DETERMINATION OF APPLICATION
TOWN AND COUNTRY PLANNING ACT 1990

FULL APPLICATION - REFUSAL

Proposal: **Erection of a single storey side, two storey rear extensions, alterations to existing roof and creation of two additional units (including accommodation within the roof space).**

Site Address: **7 Willis Road, Southampton, SO16 2NS**

Drawing No.
 2019/03

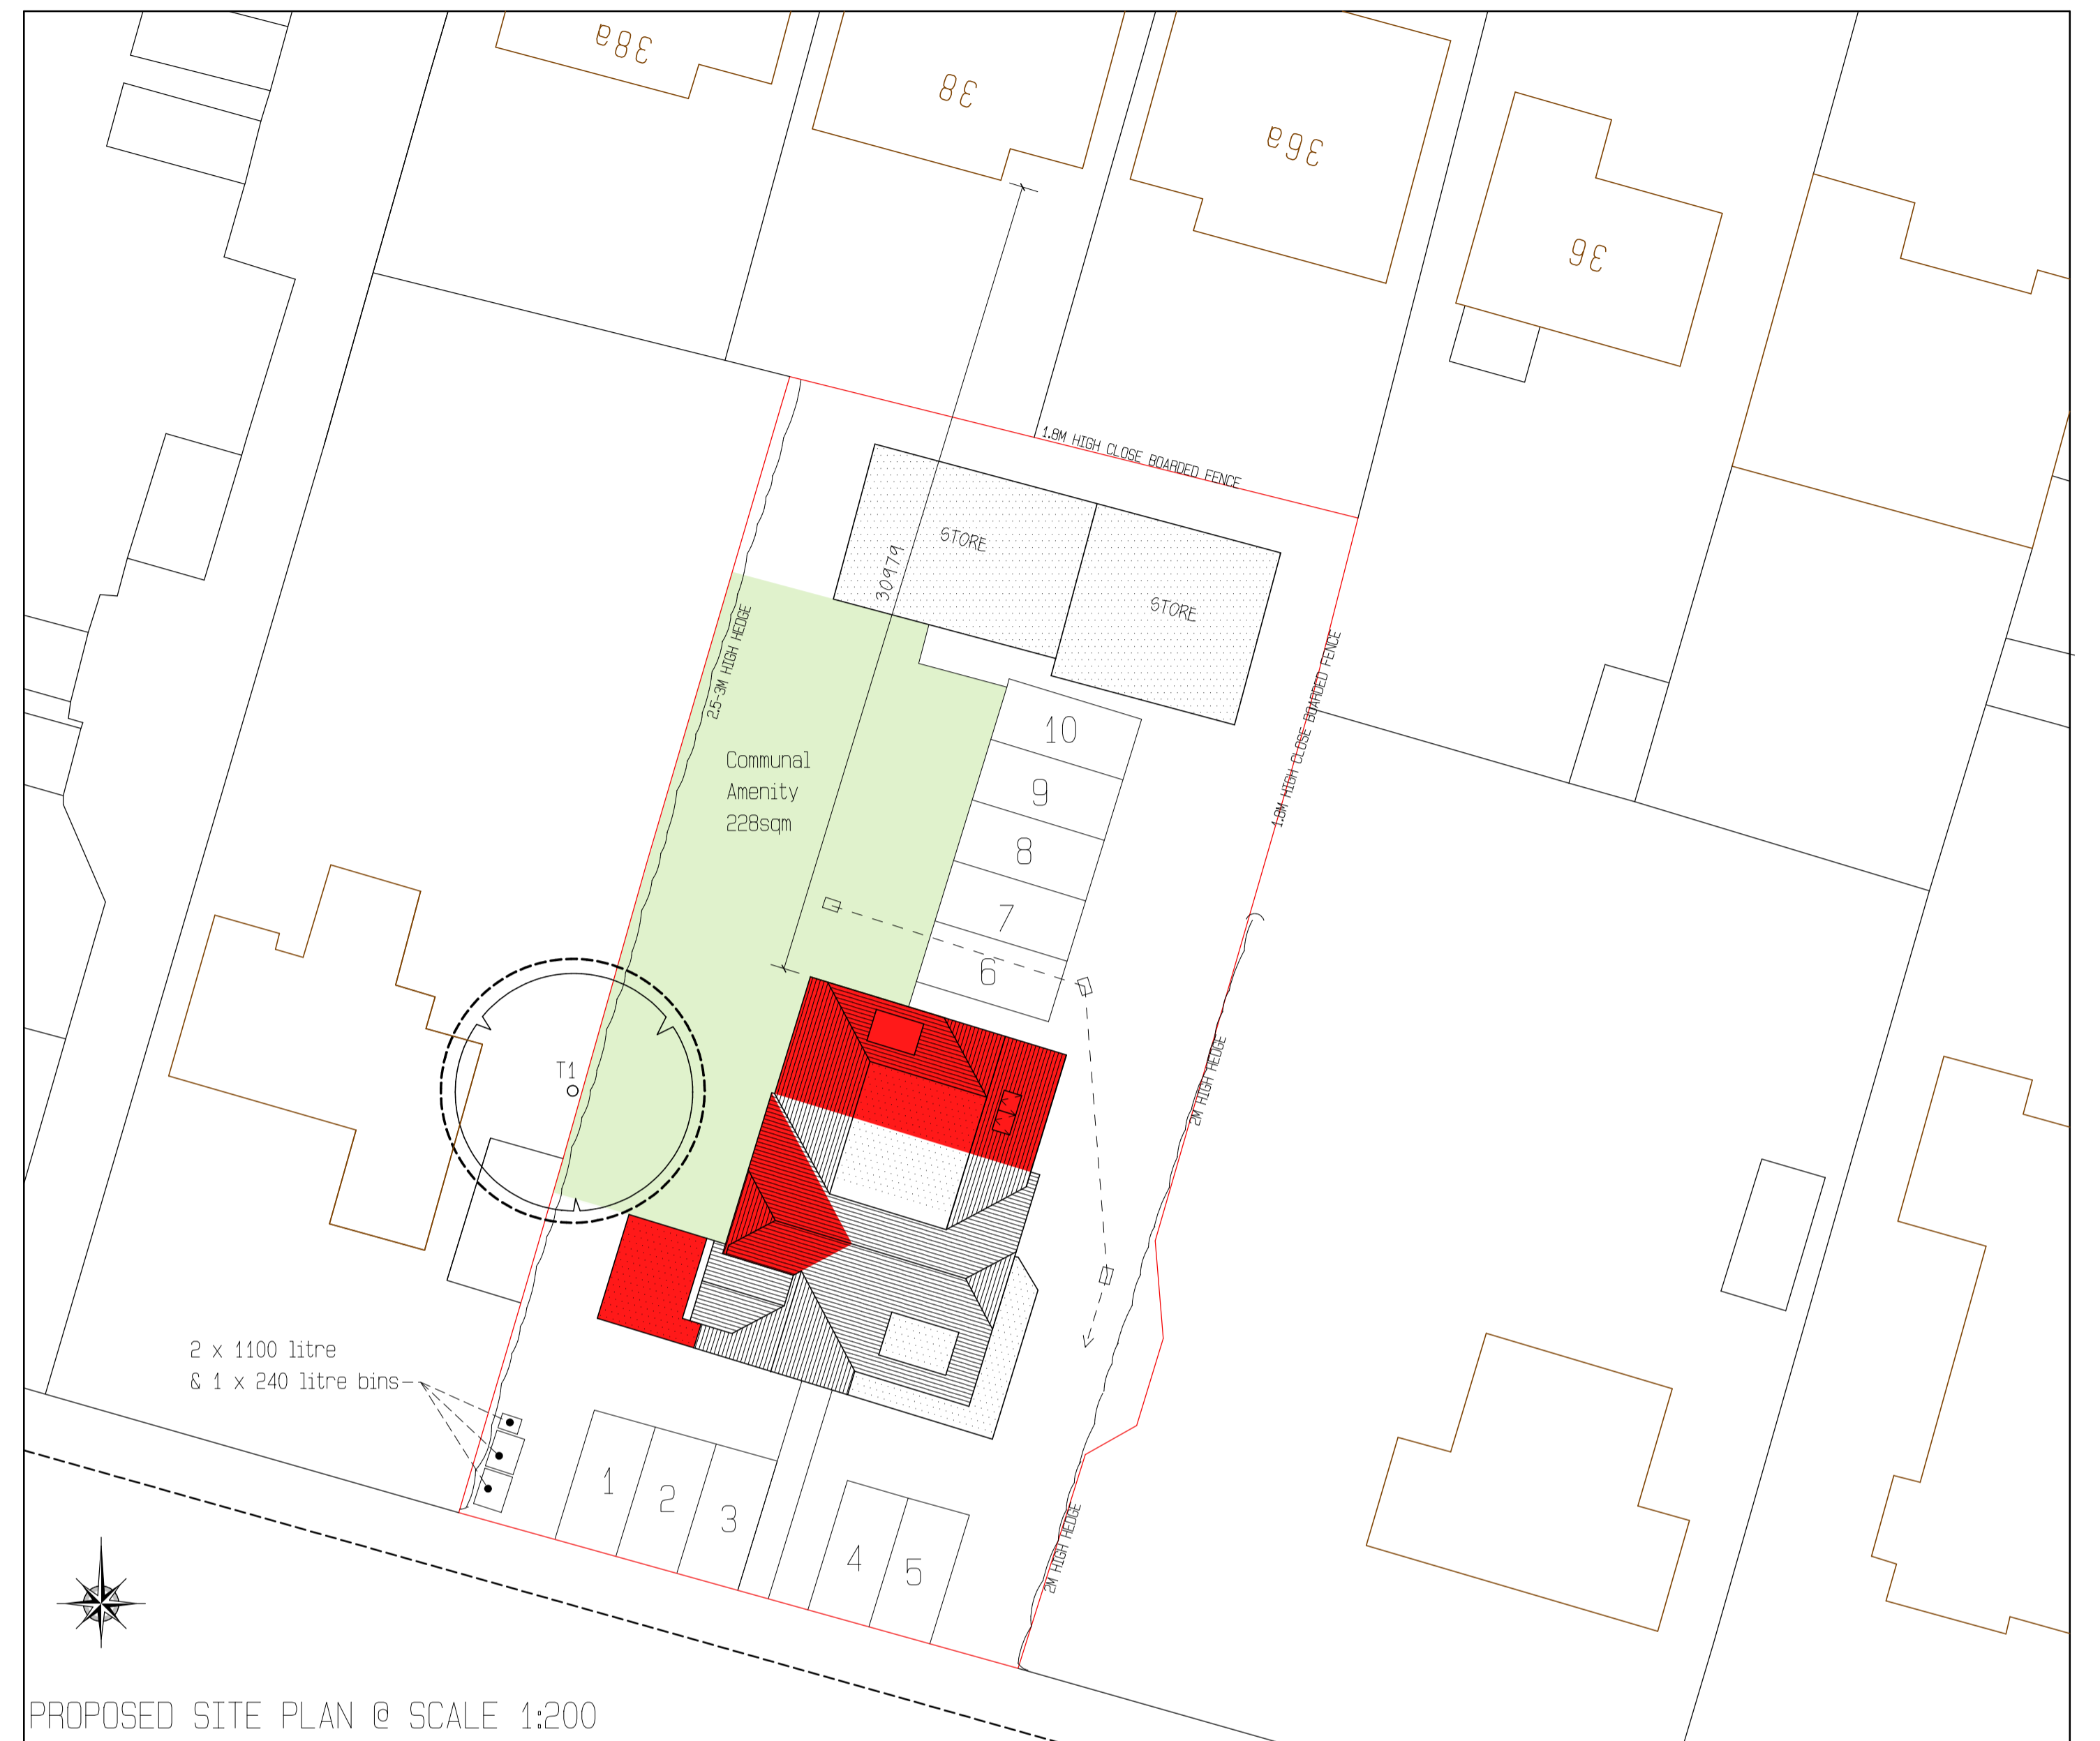
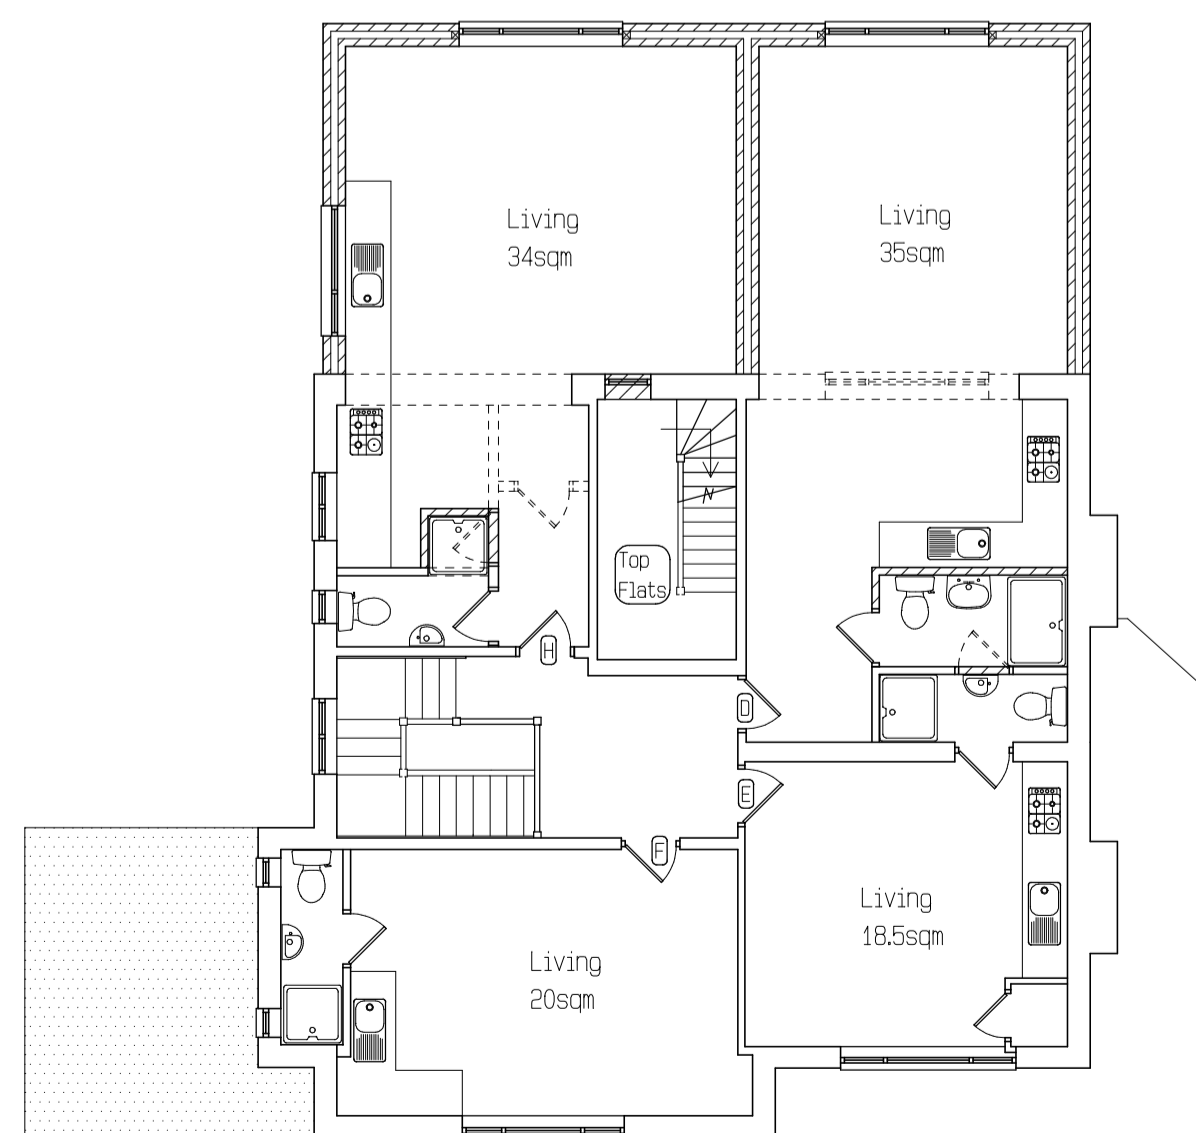
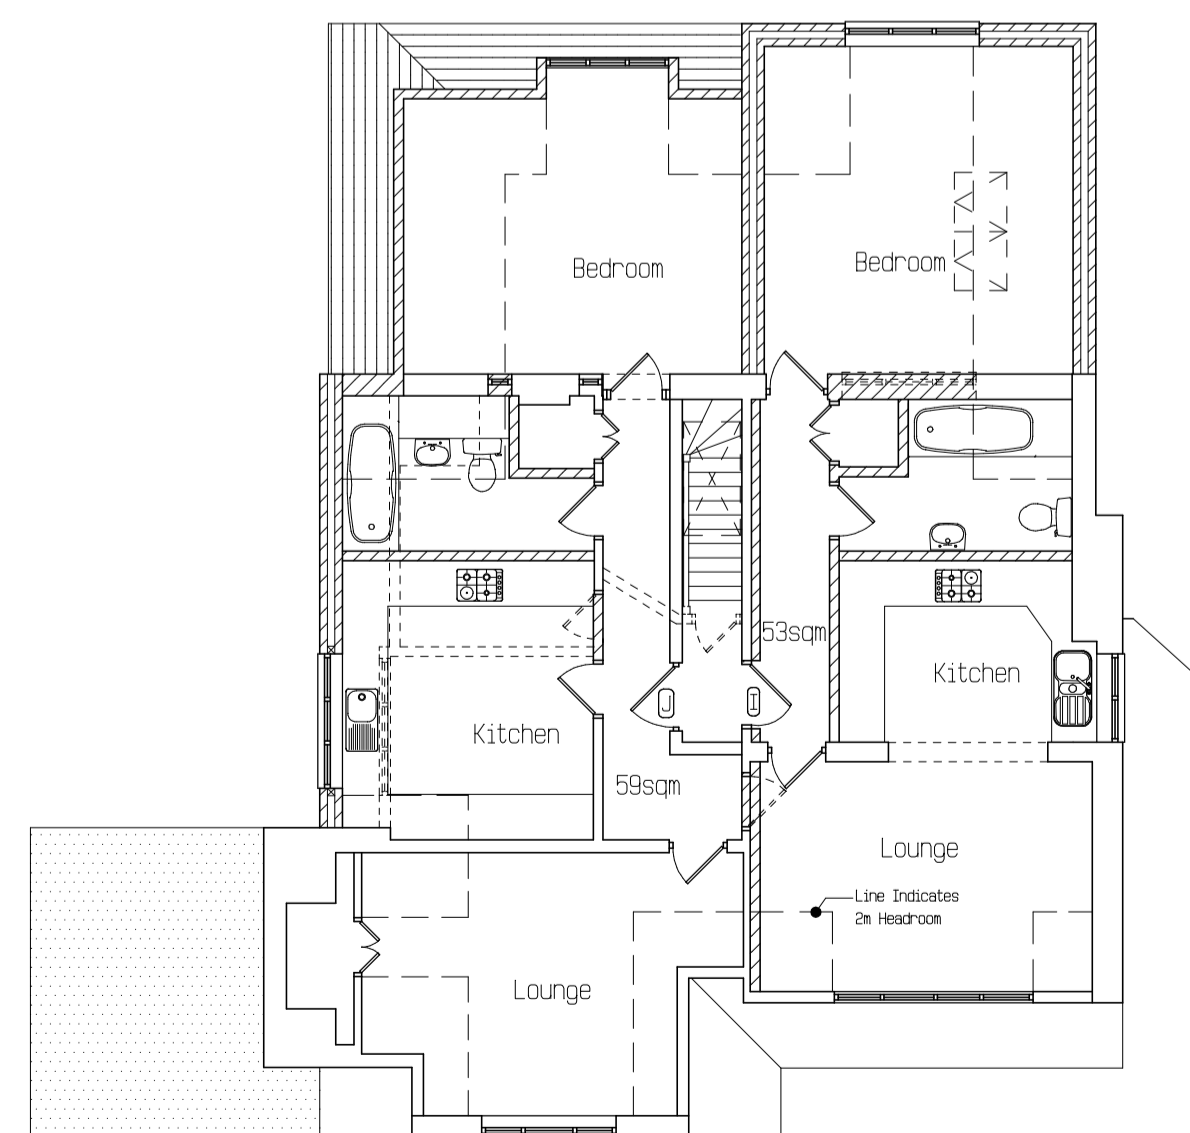
01.Out of Character

The mass and bulk of the proposed first and second floor extensions in terms of their rearward projection and height (to eaves and ridge line) would over-dominate the character and proportions of the host property. Furthermore, the roof extension would appear disproportionate and top heavy to the appearance of the main roof. As such, the proposal would adversely affect the character and appearance of the local area and therefore would be contrary to saved policies SDP1, SDP7, SDP9 of the Local Plan Review (March 2015 amended) and CS13 of the Core Strategy (March 2015 amended) as supported by the relevant design guidance set out in section 2 of the Residential Design Guide Supplementary Planning Document (September 2006).

03.Poor living conditions

A number of the proposed studio flats fall significantly under the guideline of the minimum floor area as set out the the national described floor space standards (dated March 2015) . Notwithstanding that the quality of the accommodation in part is being improved by providing self contained wash and toilet facilities, the small and tight size of the flats are not characteristic of the type of accommodation found this suburban location. The small cramped nature of these units are considered to create inadequate living conditions to the detriment of the future occupants. Furthermore, limited weight should be given to the quality of the existing accommodation due to the uncertainty of the lawfulness of the residential units. As such, the proposal is

considered to be contrary to saved policy SDP1(i) and H7 of the Local Plan Review (March 2015 amended) as the development would fail to provide high standard of residential design nor a good standard of amenity for the future occupants and section 2 of the Residential Design Guide (2006).
